Contract #: 04-0120F4Cty: SF/ALA Rte: 80 PM: 13.2/13.9File #: 69.25B**QUALITY ASSURANCE -- NON-CONFORMANCE REPORT****Location:** Changxing Island, Shanghai, P.R. China**Report No:** NCR-000395**Prime Contractor:** American Bridge/Fluor Enterprises, a JV**Date:** 13-Aug-2009**Submitting Contractor:** Zhenhua Port Machinery Company, Ltd (ZPMC), Changxing Island**NCR #:** ZPMC-0369**Type of problem:****Welding****Concrete****Other****Welding****Curing****Procedural****Bridge No:** 34-0006**Joint fit-up****Coating****Other****Component:** OBG Bottom Plate BP026**Procedural****Procedural****Description:****Reference Description:** Missed MT Indications by QC on OBG Bottom Panel BP26**Description of Non-Conformance:**

NON-CONFORMANCE REPORT TRANSMITTAL

Job Name: SAS Superstructure

Subject: NCR No. ZPMC-0369

项目名称 Project Name:	美国海湾大桥 SFOBB	部件图号 Drawing No.:	BP026-009	报告编号 Report No.:	B-CWR679
合同号 Contract No.:	04-0120F4	部件名称 Item Name:	箱梁底板 Box Bottom Plate	NDT 报告编号 NDT Report No.:	NA
项目编号 Project No.:	ZP06-787

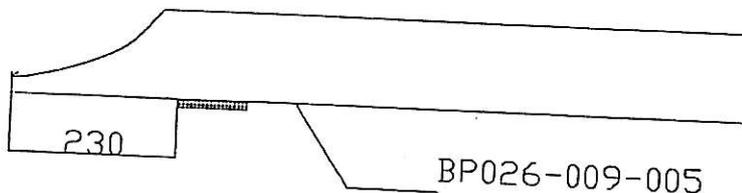
对焊缝进行目检时发现焊缝BP026-009-005存在长度为70mm的裂纹。

The crack was found on weld (BP026-009-005) after view inspection, 70mm in length.

1. QC and a Lead CWI shall be present, direct and supervise all grinding and welding operations during this repair to ensure the repair is per the disposition requirements

2. QC and a Lead CWI shall have an approved copy of the CWR in hand prior to the repair.
3. Remove paint ≥ 25 mm in all direction of HAZ prior to MT.
4. Remove cracks by grinding, repair area shall extend a minimum of 50mm beyond each end of single crack repairs;

5. If base metal is damaged by grinding, the damaged area shall be ground clean prior to performing weld repair. If gap > 5 mm is found during or after grinding, a separate CWR to make the weld joint a CJP is required in that location, and perform MT after performing grinding the defects away, if CJP joint is required, separate CWR approval is required.

6. Prepare excavation in accordance with an approved repair WPS prior to welding.
7. Before this repair, Verify with VT and MT repair areas are defects free;

8. Perform MT on the weld metal adjacent to the repair area to ensure that crack did not propagate into base metal. If crack is discovered in base metal, approval of a separate CWR is required before continuing with repair work.

9. Preheat and weld according to the approved repair WPS.
10. Grind the repaired area flush with base metal or the adjacent weld.
11. Perform NDT in accordance weld contract plans & adjacent NDT weld note 3 inspections and test. (along with an additional 50mm at each end of the weld repair) which include the near side and far side on the upper Perform UT and MT inspection to CJP weld.
